## HISTORIC SITE PRESERVATION BOARD STAFF REPORT

DATE: February 13, 2018 NEW BUSINESS

SUBJECT: GERGIS YOUSEF, OWNER, FOR A CERTIFICATE OF APPROVAL FOR ALTERATIONS TO "THE SHELL GAS STATION" LOCATED AT 2796 NORTH PALM CANYON DRIVE (CASE 3.1912 MAA / HSPB #99) (DN).

*Image of Westerly End of Canopy Underside:*

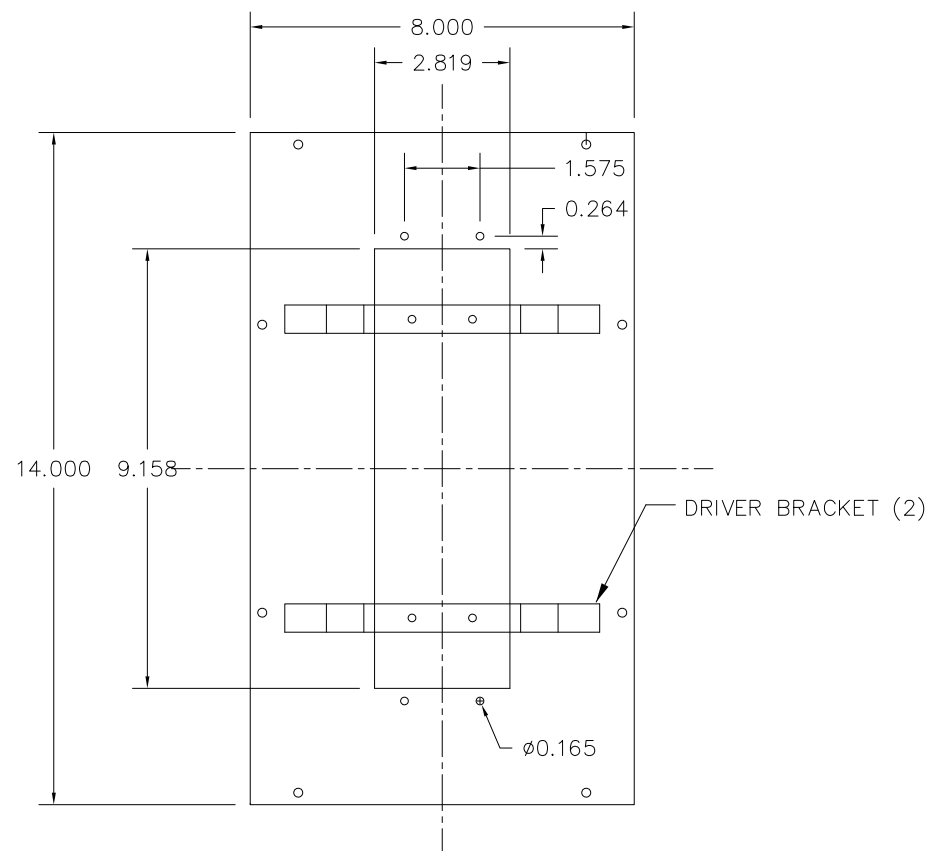
Approve the proposed changes and issue a certificate of approval to the Building Official, excluding the two new light "troffers" on the westerly end of the canopy.

Two new recessed fixtures are proposed at the westerly end of the canopy underside. However, these fixtures cannot be located in a similar position as the other existing fixtures which are centered between the "X"-bracing and support posts. The new fixtures would be off-set closer to the support post and depart from the original design. This disrupts the simplicity and rhythm of the canopy underside and should be eliminated from the project.

PHOTOMETRIC SITE PLAN

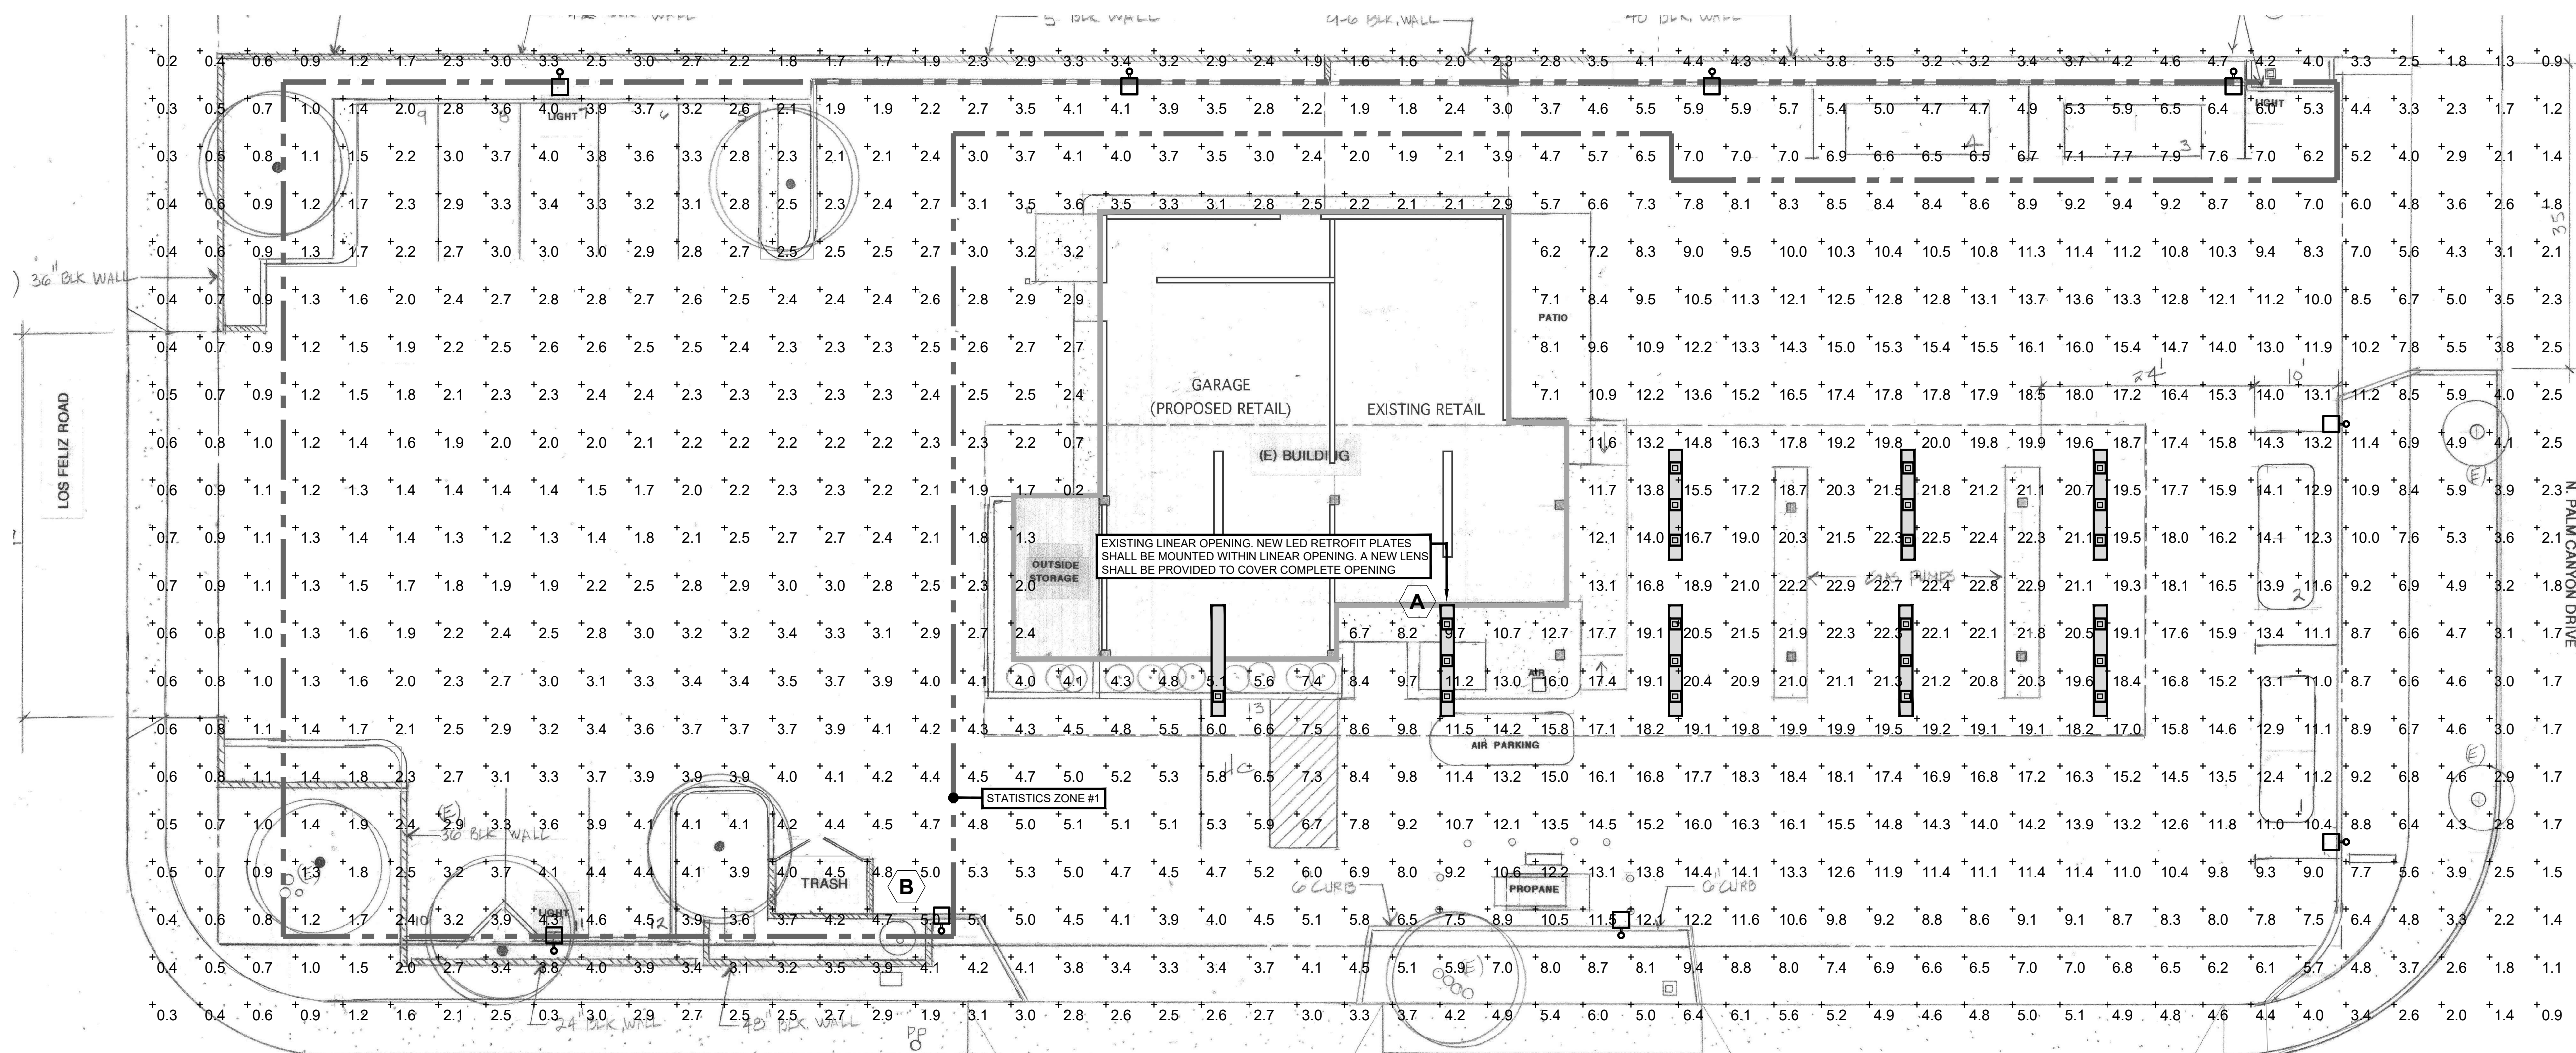
Thank you for sending the revised plan. There is one issue with the two fixtures at the westerly end of the canopy. These are proposed where there are no existing recessed lighting channels. How will these be installed? Or are these shown in error?

The 2 fixtures at the end of the canopy would be mounted recessed like the others. The contractor would saw cut the canopy to match the other recess openings. Based on my site investigation with the contractor this can be easily accomplished.

The 2 end fixtures are required to properly illuminate the drive and pump area.
